SERVICE MANUAL BULLETIN

SMB-152

ISSUE DATE: Dec 10 2015

APPLICABILITY					
VEHICLE LENGTH	□ 30ft.	□ 35ft.	□ 40ft.	□ 60ft.	■ ALL
VEHICLE TYPE	☐ High Floor	■ Low Floor	■ Invero®	■ Xcelsior®	□ ALL
FUEL TYPE	□ Diesel	□ Electric	□ CNG	□ LNG	■ ALL
	☐ Diesel/Electric	☐ Gas/Electric	☐ Fuel Cell		
SUBJECT	Disc Brake Pad Installation				
SECTION TITLE	1 - FRONT AXLE & SUSPENSION - VOK-07F 2 - REAR AXLE & SUSPENSION - HY-1336-P HY-1350-F				
DETAILS	This bulletin provides revised OEM information on the installation of the disc brake pads on your New Flyer Vehicle.				
This bulletin supersedes all prior information on this subject vided in your New Flyer Service Manuals and SMB-149 released. 20, 2015. Make this Service Bulletin available to service persinform them of changed information.					October

Fig. 1: Areas to Apply Lubricant

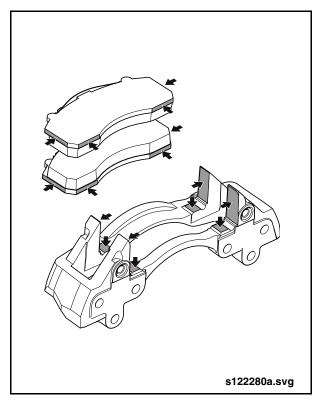
It may be necessary for the abutments of the carrier and guiding surfaces of the brake pad to be coated with a suitable permanent lubricant. See "Fig. 1: Areas to Apply Lubricant" on page 2. The following products are approved for this application: Textar CERA TEC®, ATE Plastilube®, Dow Corning P-40® Paste.

DO NOT use copper based lubricant. DO NOT get any lubricant on the pad and/or disc face or guide sleeve parts.
